PART BASEMENT FLOOR PLAN NO.1 - NEW WORK

PAN AM POOL - EAST VESTIBULES

ADDENDUM NO.2

RM-2

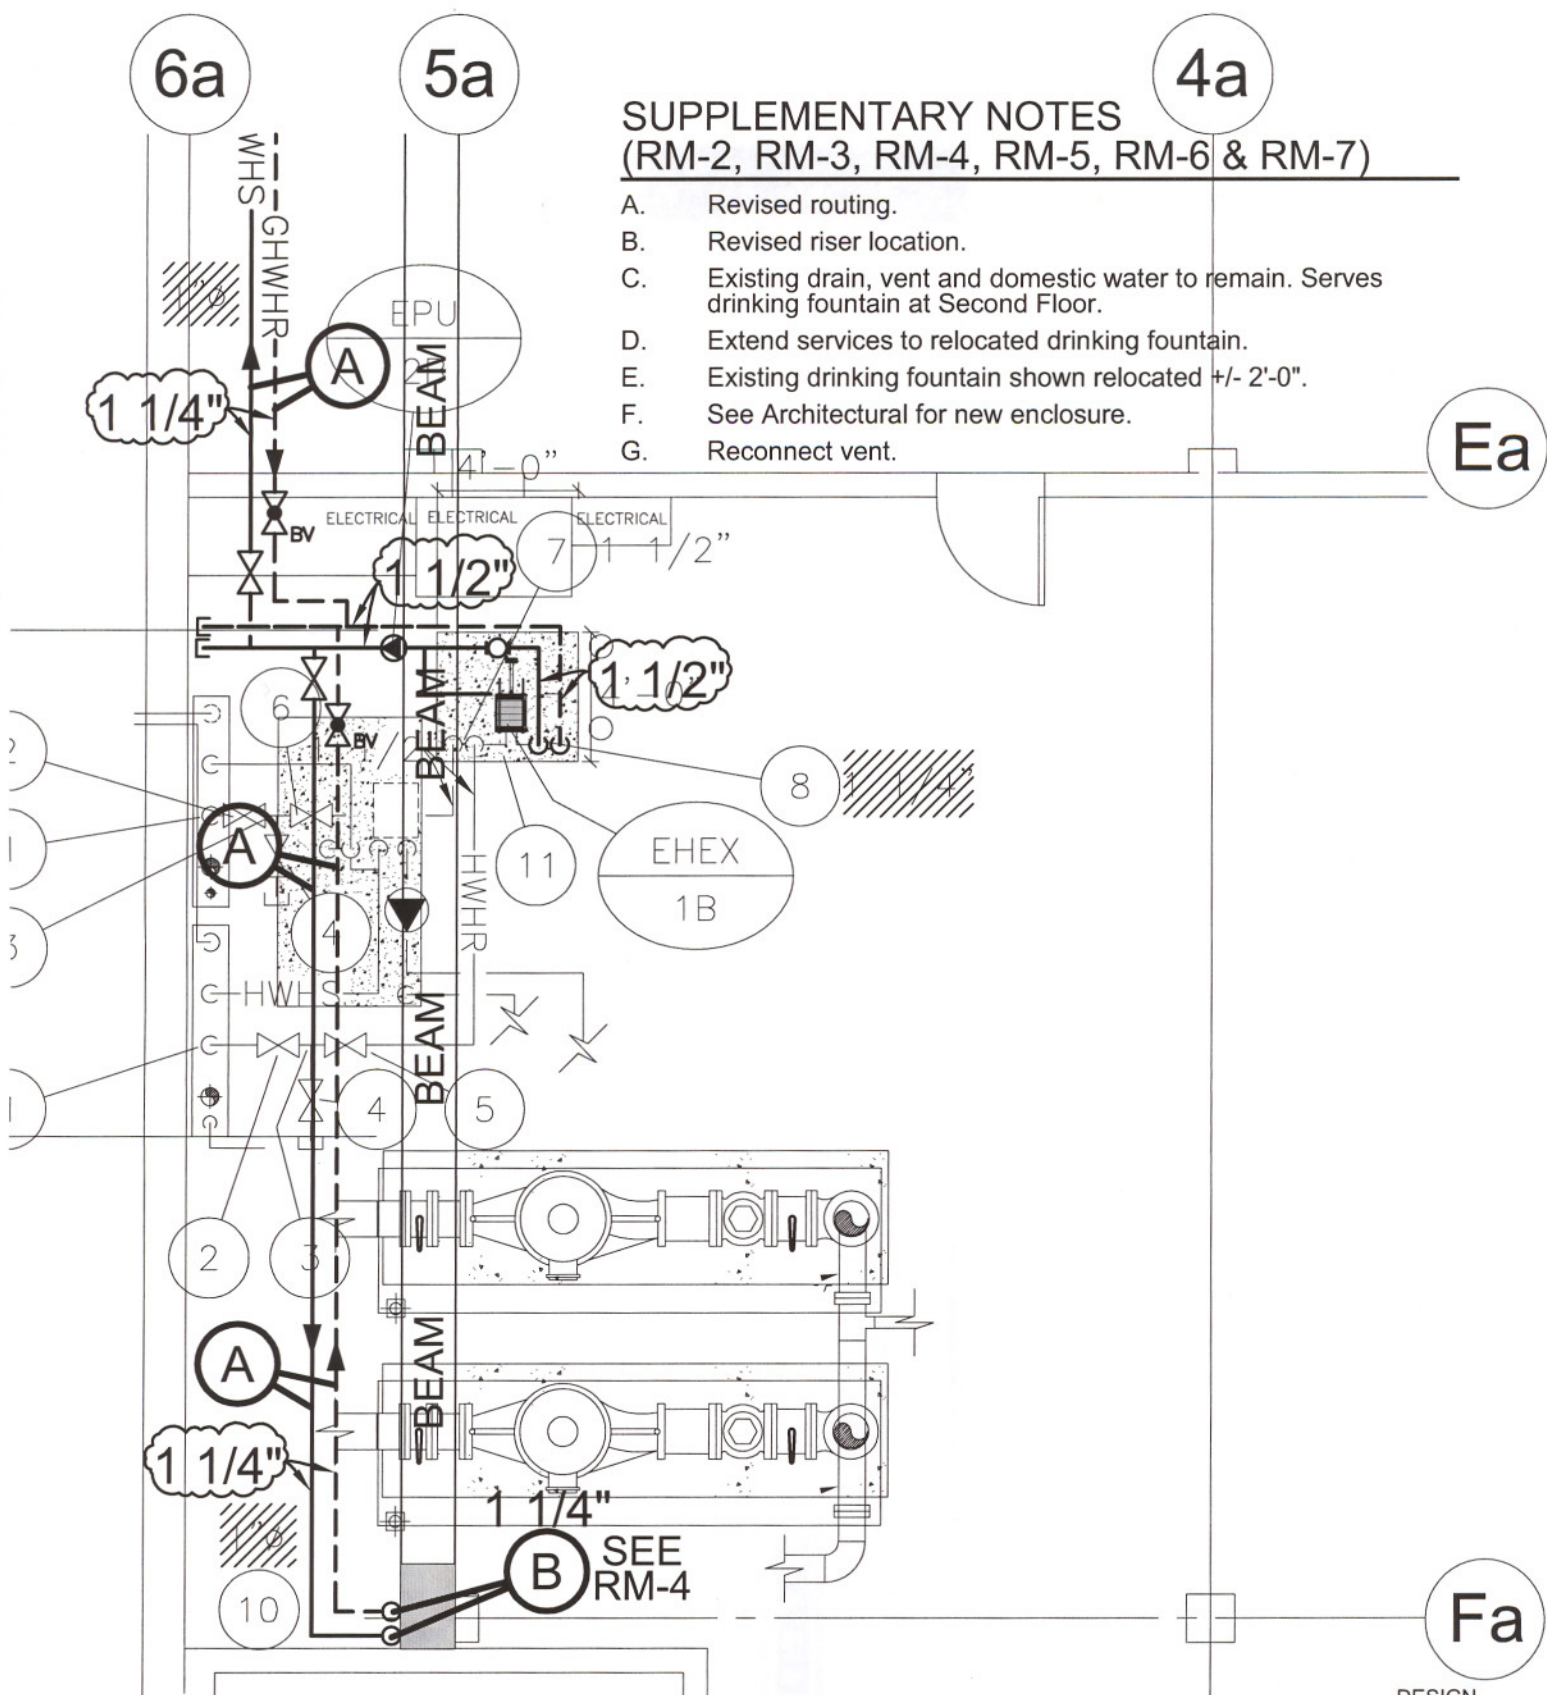
- A. Revised routing.
- B. Revised riser location.
- C. Existing drain, vent and domestic water to remain. Serves drinking fountain at Second Floor.
- D. Extend services to relocated drinking fountain.
- E. Existing drinking fountain shown relocated +/- 2'-0".
- F. See Architectural for new enclosure.
- G. Reconnect vent.
